EASTGATE COMMERCIAL PARK, PHASE II

FINAL DEVELOPMENT PLAN

Re: Project 611-659 Eastgate Commercial Park, Phase II – Final Development Plan

RE: Project 611-659 Eastgate Pkwy Final Development Plan

WATERLINE PLAN

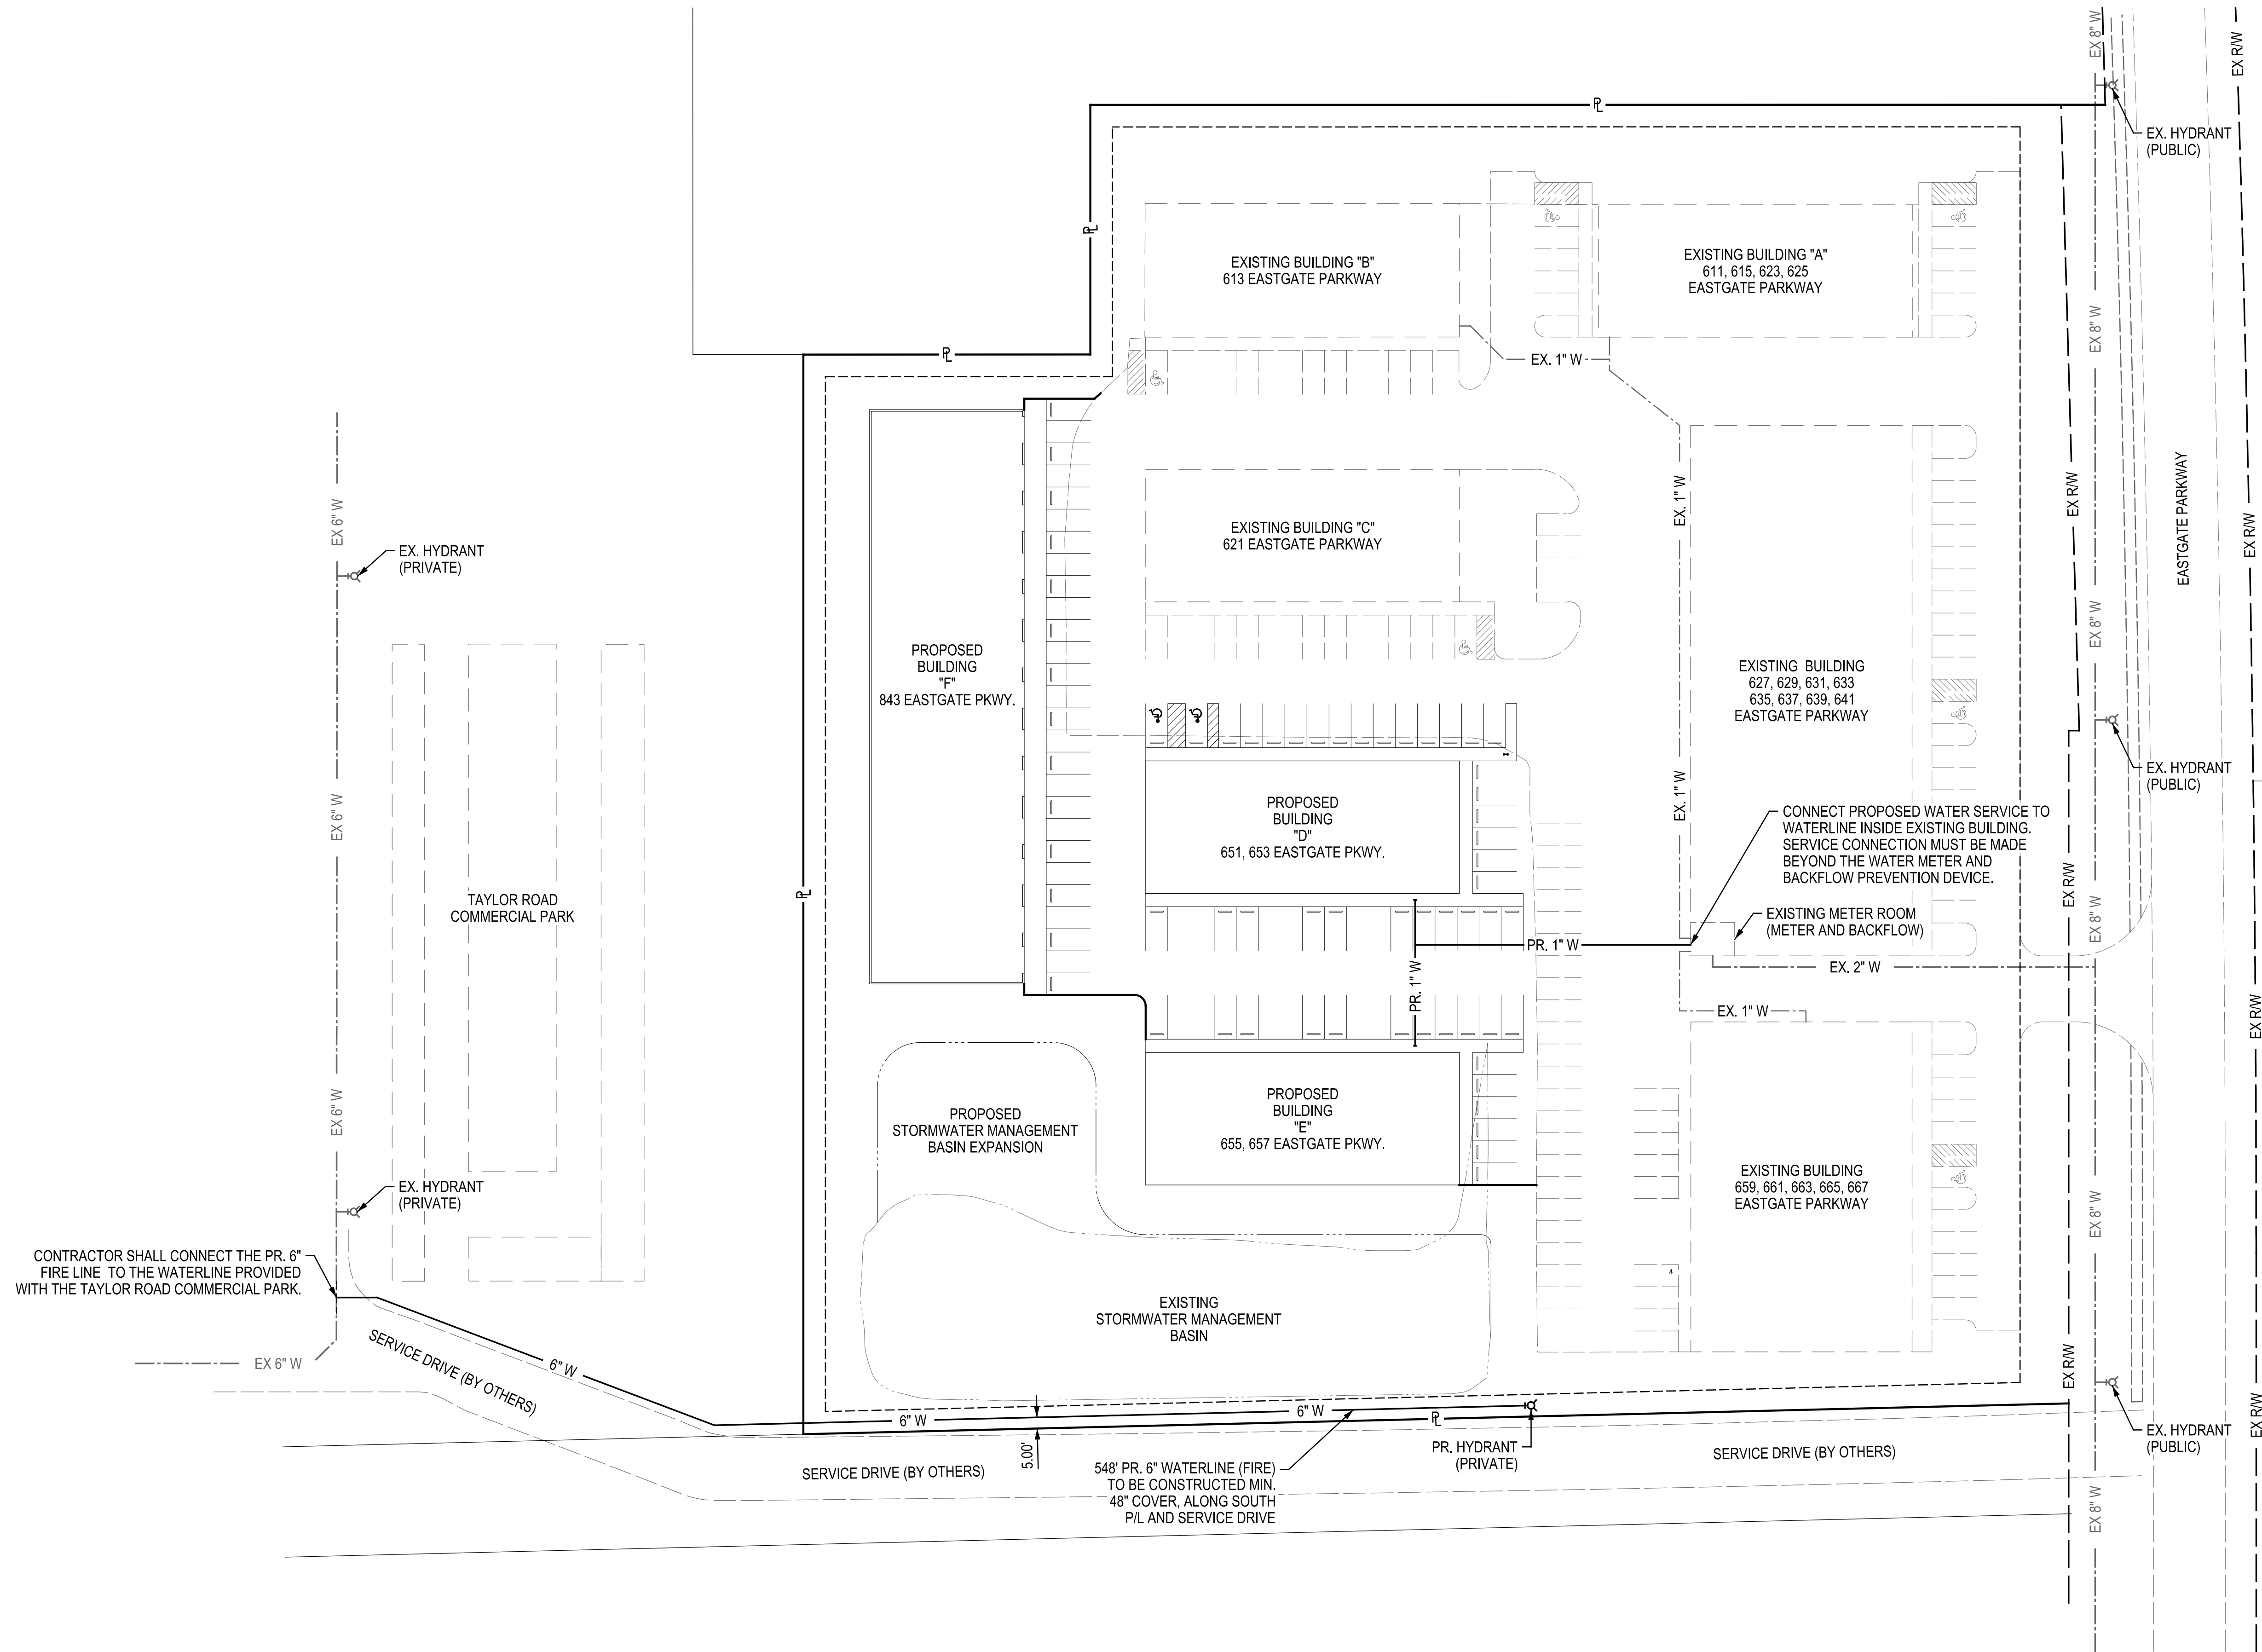
8. I found an issue with Submittal 2 for 611-659 Eastgate Parkway. The back building 643 Eastgate Parkway (parallel to property line) is over 1000 feet from the closest fire hydrant. An additional fire hydrant(s) is required. *Fire hydrant has been added on the south end of this building via an extension from the neighboring development, with an easement. As shown on the revised plans.*

CONTRACTOR SHALL CONNECT THE PR. 6" FIRE LINE TO THE WATERLINE PROVIDED WITH THE TAYLOR ROAD COMMERCIAL PARK.
